Rathborne Village Residents Committee
C/O 13 The Waxworks
Rathborne Village
Ashtown
Dublin 15
D15 YX92

27 October 2022

Subject: DART+ West Railway Order Application

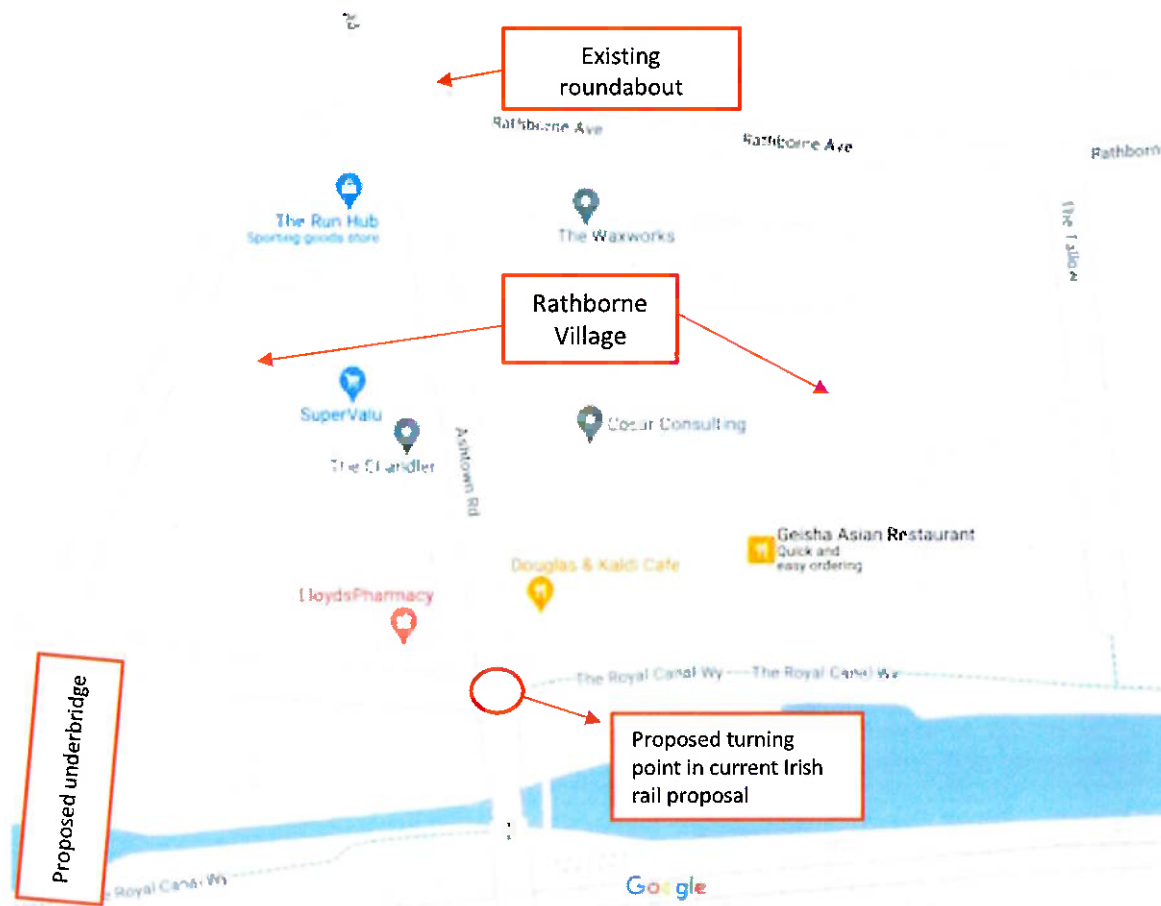
Ashtown road will effectively become a cul de sac both sides of the canal. To the north, the road runs through Rathborne Village. The current Irish Rail proposals have a turning/drop-off point just before Longford Bridge where the road ends⁷ (see map below). crossing greater attention needs to be paid to the public realm. We propose that changes to the road and the public realm in Rathborne Village need to be considered as part of the Irish Rail plans, including allowance to amend for change of use in the area, such as softer landscaping, etc. In addition, to the west of Rathborne Village, Mill Lane will become the main thoroughfare which may require changes to the roadside to reflect this.

An alternative option is to facilitate drop-off/turning at the existing round-about just north of the development at the junction with Rathborne Avenue, which would allow for the pedestrianisation of Ashtown Road through Rathborne Village (still allowing for commercial deliveries).

We propose that any approval of the railway order application is subject to the condition that Irish Rail make allowance for a change of use in the area of Rathborne Village and proactively engage with Rathborne Village Owners Management Company Limited by Guarantee, Castlethorn Construction and Dublin City Council in order to agree on the appropriate use of Ashtown Road once the level crossing is closed and appropriate enhancements to the public realm, reflecting the change of use.

Figure 4-27 Palisade fence example

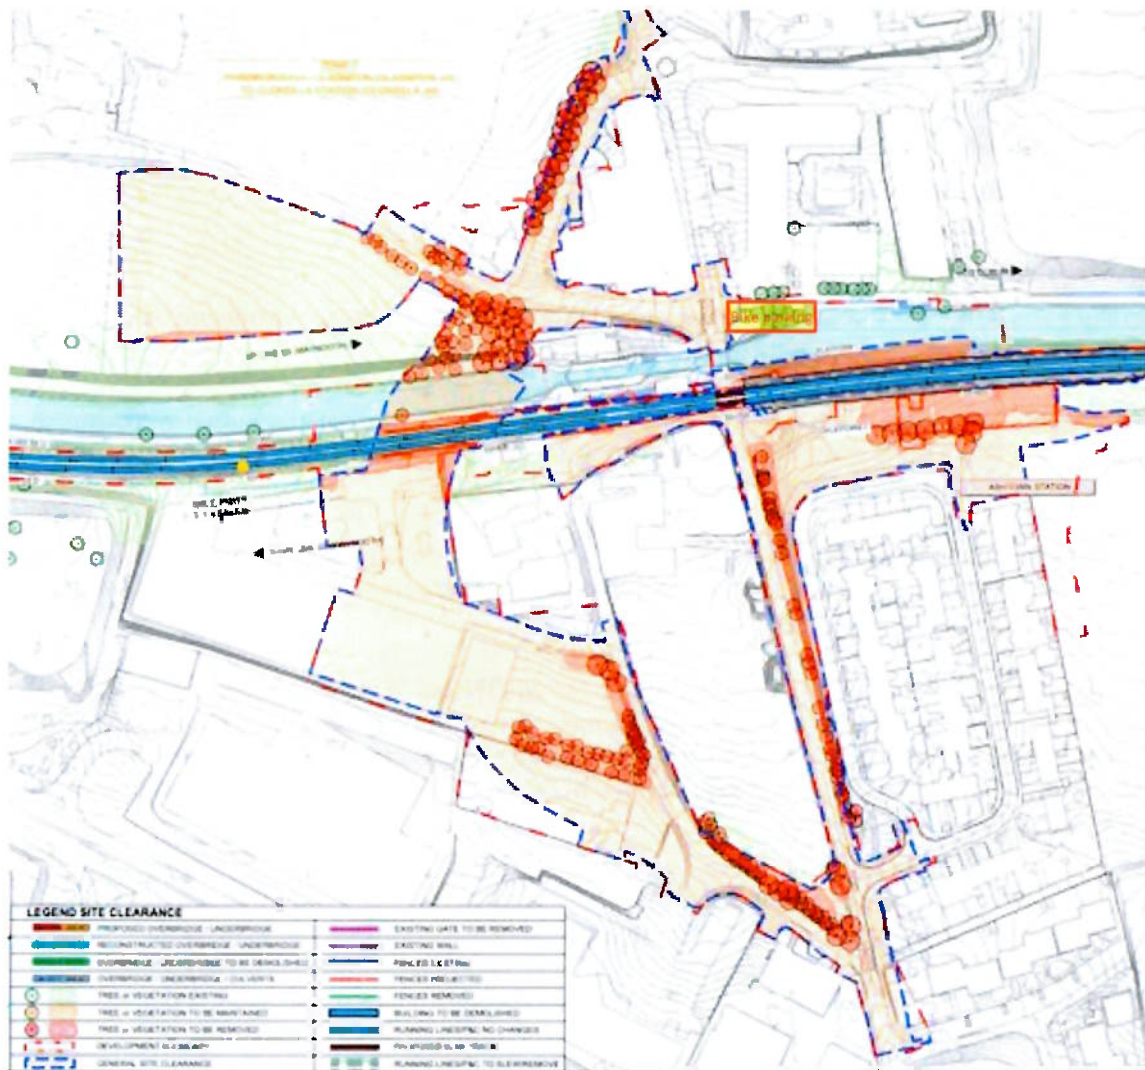
Irish Rail propose to replace the closed level crossings with palisade fencing (see section 4.5.15.2 Level crossing removals of chapter 4 of the EIAR and picture below)⁸. This fencing would be completely out of keeping with the local area. While we understand the need to secure the railway an additional wall or other more aesthetically pleasing barrier could be installed, perhaps with (artistic) reference to the manned level crossing currently in place.

We propose that any approval of the railway order application is subject to the condition that Irish Rail consider and budget for appropriate fencing or coverage of palisade fencing where it is located in more sensitive areas, such as at the location of the current level crossing adjacent to Longford bridge and engage with the local community in arriving at solutions that complement the existing public realm.

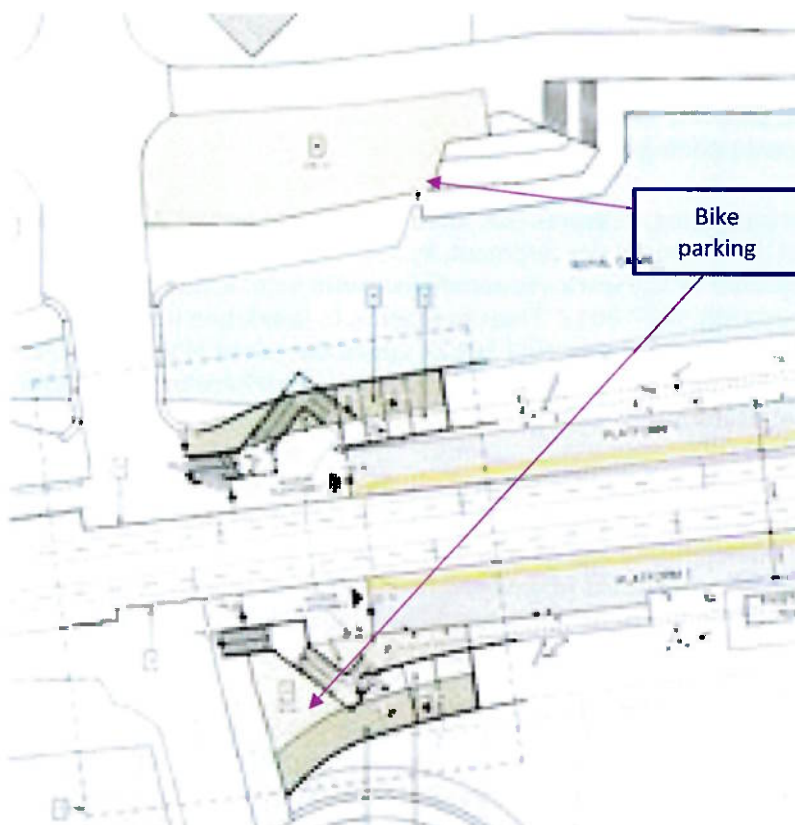
The level of tree and vegetation removal in the Ashtown area will have a substantial impact on the bio-diversity and well-being of those living in the area. We are currently fortunate to be surrounded by a significant amount of mature trees (see annex 3), but it would appear that as part of this project, including the construction phase, Irish Rail plans on removing a significant amount of trees, hedgerows and other vegetation. The clearance map below does also not make clear that at least some vegetation and possibly some trees (highlighted in yellow as an addition to the map) will be removed to facilitate bicycle parking to the north of the canal.

While there are mitigation plans to plant new trees and vegetation, which is welcome, the impact of removal of mature trees cannot be underestimated from bio-diversity, human health and climate resilience perspectives. In this context we struggle to understand why Irish Rail has

We propose that any approval of the railway order application is subject to the condition that Irish Rail (1) conduct an Arboricultural Impact Assessment and share it with An Bord Pleanála and the public prior to approval to proceed with DART+ West works; and (2) evaluate how the level of tree and vegetation loss can be minimised from the DART+ West project compared to current proposals. ¹⁴

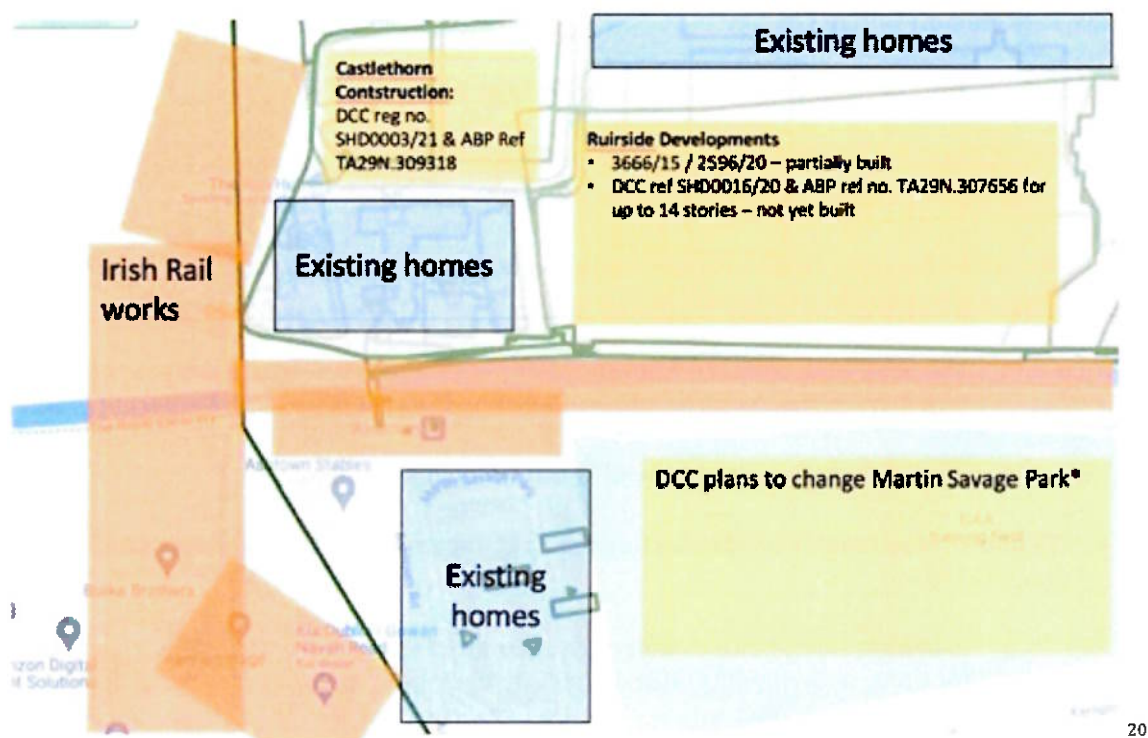
It is likely that the main works at Ashtown will coincide with works on two large developments either side of Rathborne Village (as confirmed by the developer - Castlethorn). In effect Rathborne Village is likely to be surrounded by construction sites – see diagram over the page. This further amplifies concerns raised in the section above.

What steps can be taken by Irish Rail and Dublin City Council to work with the developer to mitigate the impacts on local residents, in particular residents of Rathborne Village? For example, could the developer to minimise the impact on local residents, akin to those proposed by Irish Rail in its mitigation actions to reduce dust, etc.

We propose that any approval of the railway order application is subject to the condition that Irish Rail engage with Castlethorn construction and, if necessary, Dublin City Council, where there is contemporaneous development of sites surrounding Rathborne Village and DART+ West construction to: (1) assist in the application of similar mitigating actions in terms of dust and pollution for residents of the area; and (2) coordinate activities to minimise the impact on the area.
